GSR011: Review of Offshore Networks

NETS SQSS Review Panel
6 August 2014, John West

GSR011 – Issues Identified in Review

Page 24 – Figure 1: 2GW loss allowed time

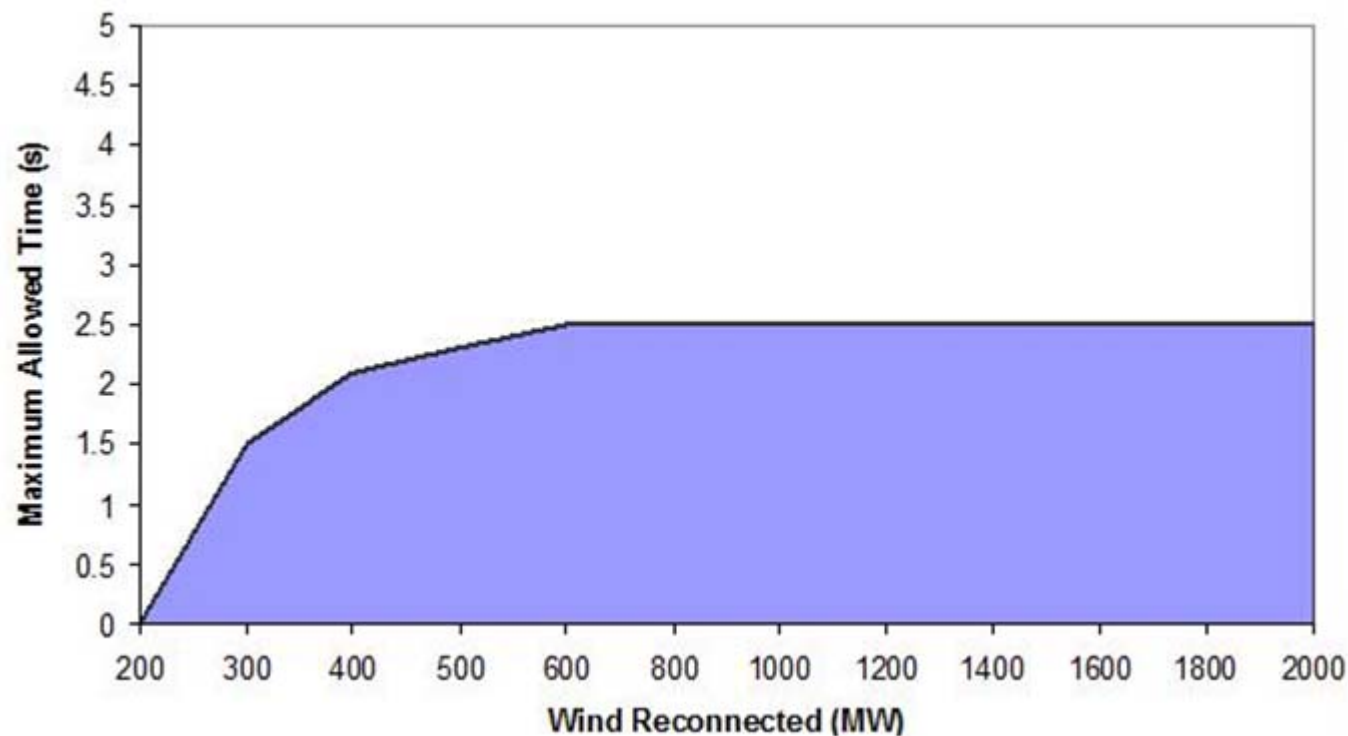
For HVDC link capacities greater than the infrequent infeed loss limit, the GSR011 analysis (Section 4.3 & Appendix F) indicates that it may be acceptable to lose more than the infrequent infeed loss limit if some generation is reconnected after a few seconds. For example:

Over the first two seconds, the Rate of Change of Frequency (RoCoF) is 0.3 to 0.4Hz / second, higher than some settings for RoCoF protections.

This issue was recognised by the working-group and the recommendation on short duration losses (Section 5) is clear that very fast restorations are likely to be required.

Short duration losses of a DC link carrying more than the Infrequent Infeed Loss can be tolerated where parallel routes can increase their flows. Analysis of system frequency performance following a loss of more than 1800MW shows that the frequency fall can be maintained within existing limits provided the loss can be quickly reduced to a level less than 1800MW – the amount of power restoration required will depend on the delay in restoring it. Whilst the frequency analysis suggests restoration times up to 2 or 3 seconds would be acceptable, it is likely that much faster restorations will be required to prevent generation instability and tripping.

The working-group has proposed a change of definition for Loss of Power Infeed such that redistribution via other HVDC links can be taken into account in assessing the Loss of Power Infeed. It is additionally proposed that this revision should emphasise the need to consider consequential losses of infeed that might occur in the redistribution timescales.
